Ref: 3995/2.3

PLOVER ROAD, MINSTER – RESIDENTIAL SITE

ADDENDUM FLOOD RISK ASSESSMENT

Proposed site drainage scheme 3995/SK100C

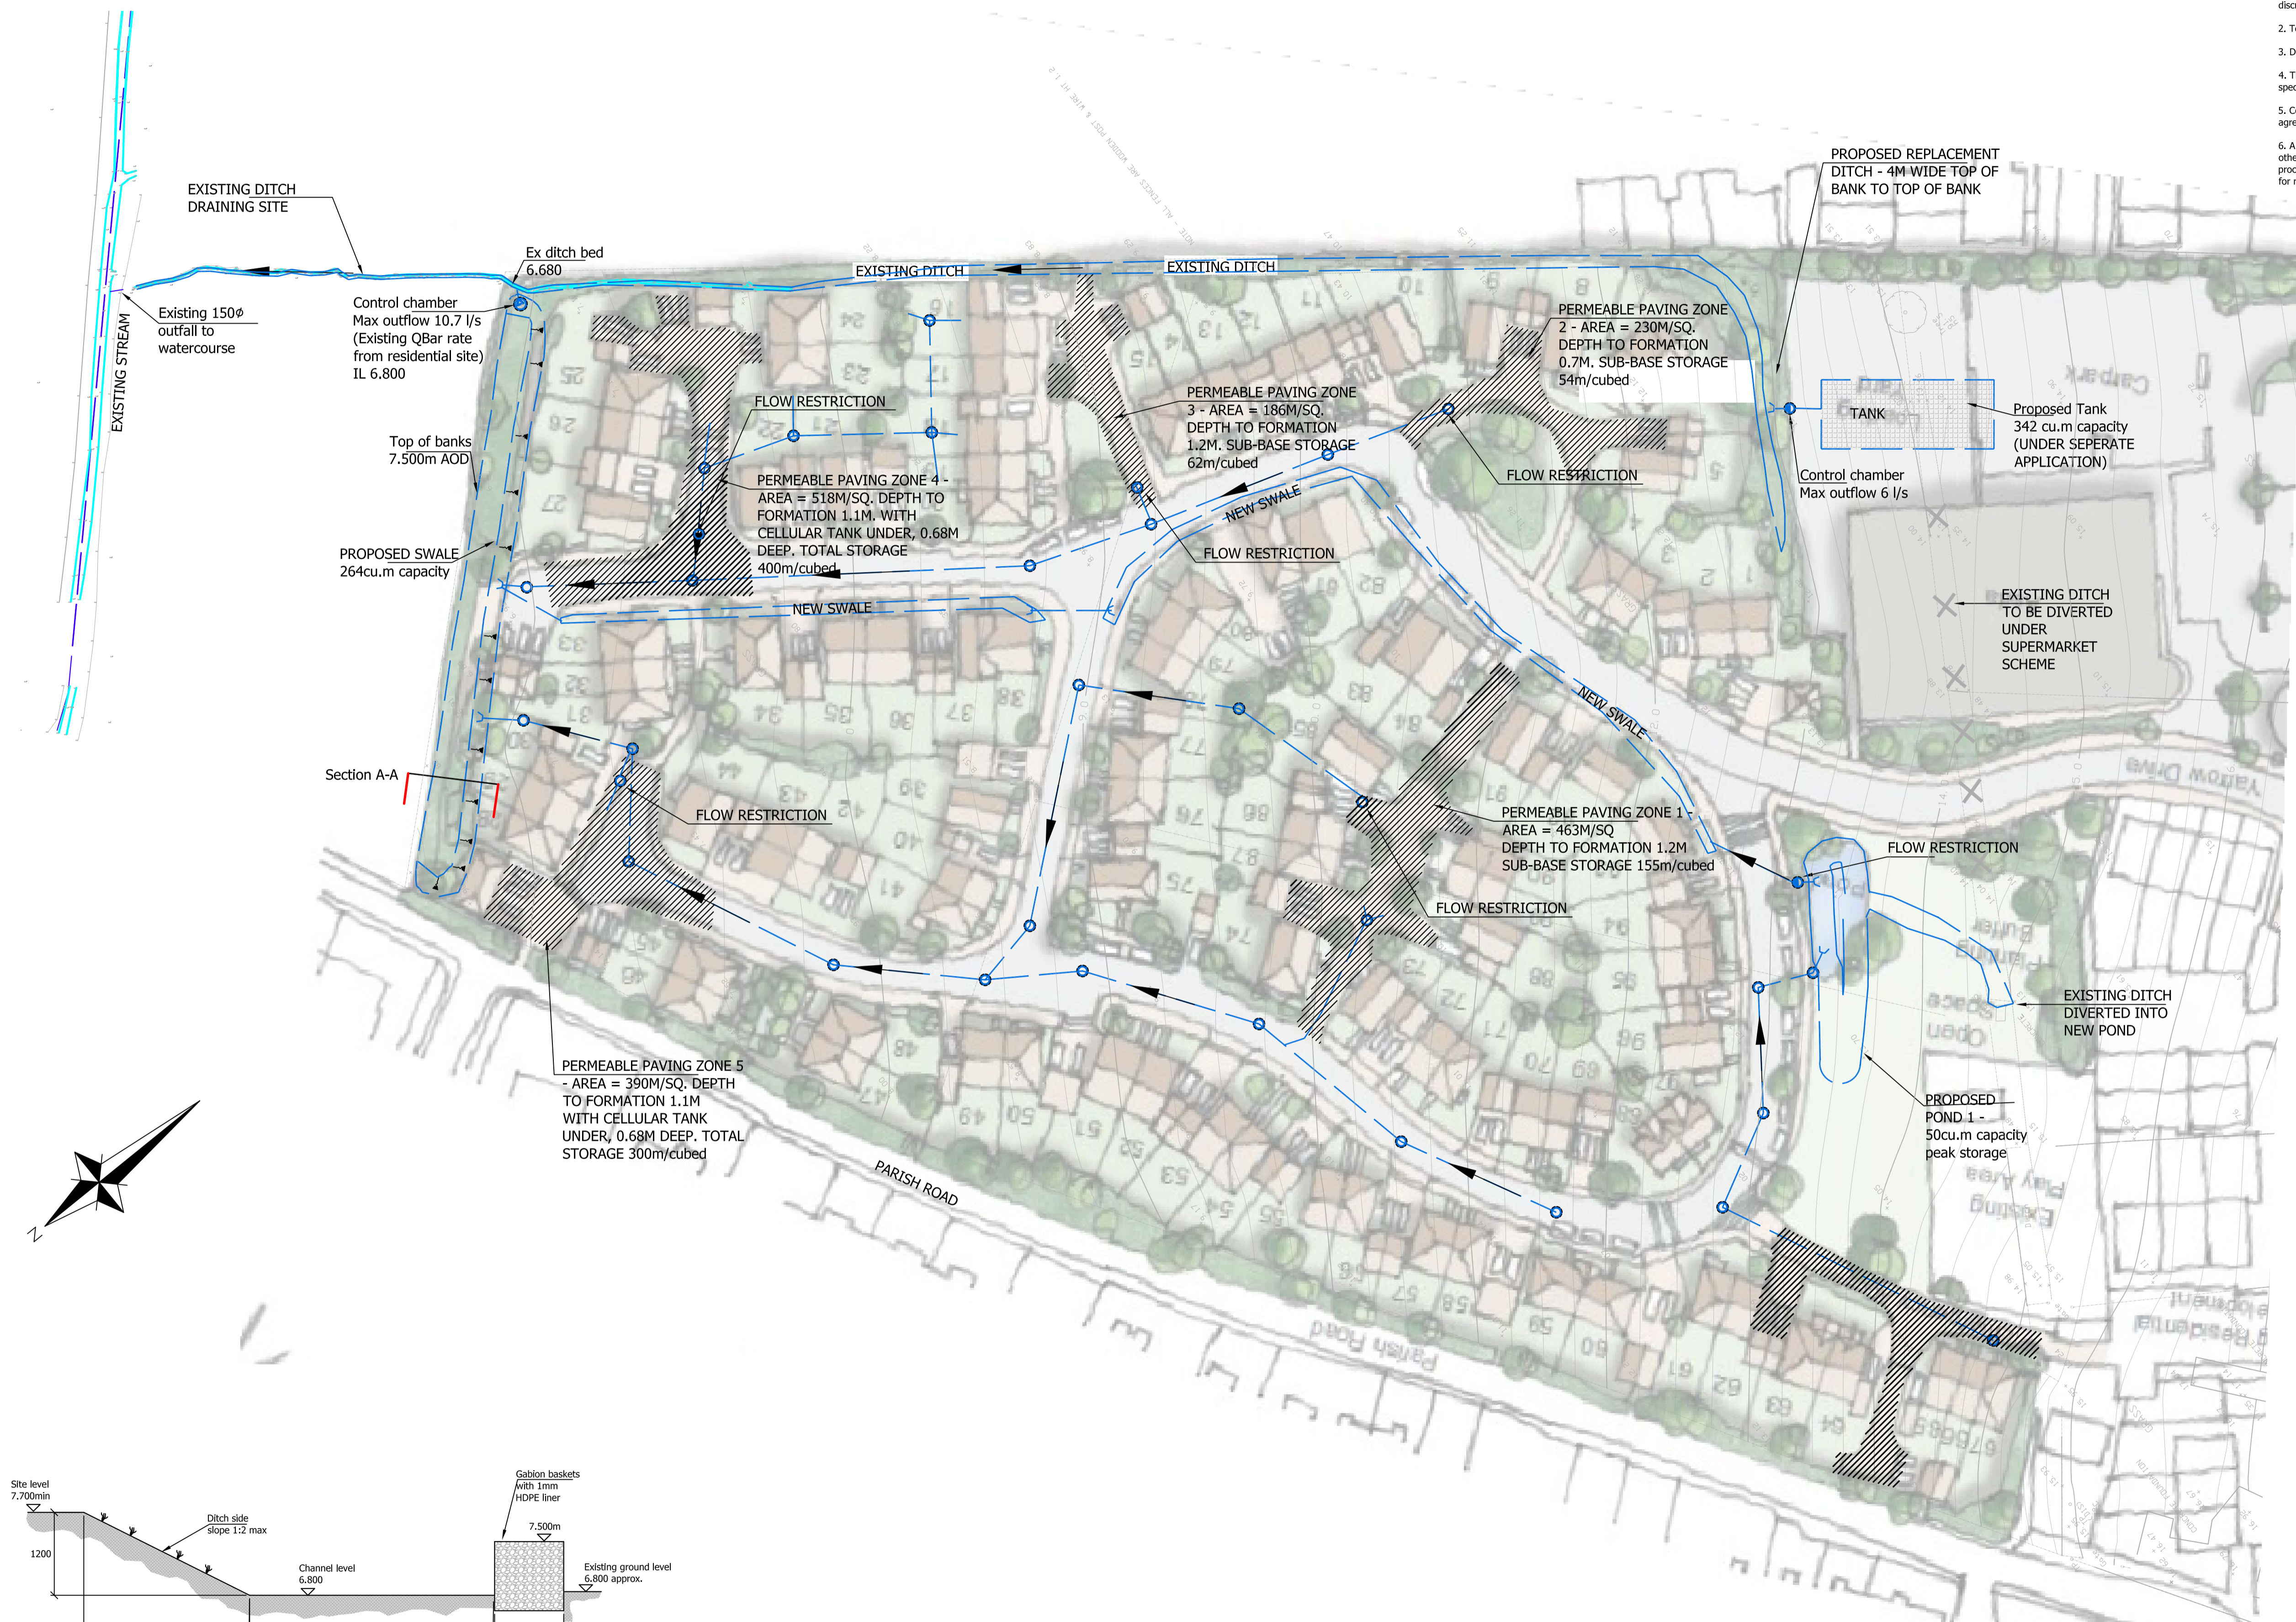
The comments from the IDB and Mid Kent planning team were that the proposed off site flow rate of 31l/s for the site was too high as this was based on the existing 1 in 100 year flow rate.

The Mid Kent Planning team also made comments regarding the off site 450mm surface water drain proposed. Since these comments further survey work were carried out to clear vegetation from the northern boundary and an existing ditch was discovered which conveys existing flows from the fields to the existing Scrapsgate Drain, with a pipe link under the footpath running parallel to this watercourse.

The Mid Kent planning team also raised concerns over the diversion of the existing ditch serving the existing housing estate to the east, particularly with regards to the 90 degree bend.

We also have concerns with the depicted realignment of the existing ditch and would encourage the applicant to reconsider the proposed 90 degree bend. It would facilitate the conveyance of water and the maintenance of the drainage network if this were redesigned to run in a straight line alongside the new highway. The depicted attenuation pond could be redesigned to be an online feature (with a flow control device limiting the rate of discharge downstream). This may require a small amount of reprofiling of the open green space, but we would not anticipate any significant difficulties in achieving

The applicant states that the existing runoff rates from the site, including an adjacent site for a foodstore (ref 15/505670), have been calculated to be 9.7l/s (Qbar) and 31l/s (Q100) and proposes to attenuate post-development runoff to a rate of 31l/s. Whilst it is very much agreed that the wider site should be considered, the overall rate of discharge should ideally be restricted to 9.7l/s, but at the very least should be replicate Greenfield conditions (if runoff was restricted to this higher rate, local flood risk during lower than 1 in 100 year events would be increased). I therefore **object** to the proposal as currently detailed.

It is therefore proposed to discharge to the existing QBar rate of 10.7l/s, which is based on the residential site area of 3 hectares. See Microdrainage ICP SUDS rural run-off summary within Appendix B.

A topographical survey was carried out to survey this ditch and the scheme was re-designed to suit the existing invert level. The proposed storage swale invert was raised to 6.800 from the previously submitted design which has reduced the capacity of this swale.

To compensate, storage is proposed to be spread through the site into 5 main permeable paved areas, each with flow restrictions.

The storage potential of each area is summarised in the table on drawing 3995/SK100 rev C in Appendix B, but also replicated below:

The scheme has been re-designed to take the ditch into the Upper pond, which will then be drained through the site via a new swale to the side of the road. It is still proposed to retain an existing ditch to the eastern boundary as it is felt that filling this ditch would present a land drainage problem as the adjacent site may also discharge to some extent into this. The supermarket site will also discharge to this ditch.

Rev	Comments	Date	By	Chk
C	Updated to latest site layout and KCC/IDB comments	23.01.16	MR	NS
Status: PRELIMINARY				
Client: DALEMARCH SHEPPY LTD				
Architect: BDB				
Project: PROPOSED MIX DEVELOPMENT LAND OFF PLOVER ROAD, SHEPPY				
Title: SURFACE WATER DRAINAGE STRATEGY				
Date:	APRIL 2012	Scale @ A1:	1:500	
Base Layout Ref.		CAO File ref.		
Clients Ref.		Project Ref.	3995
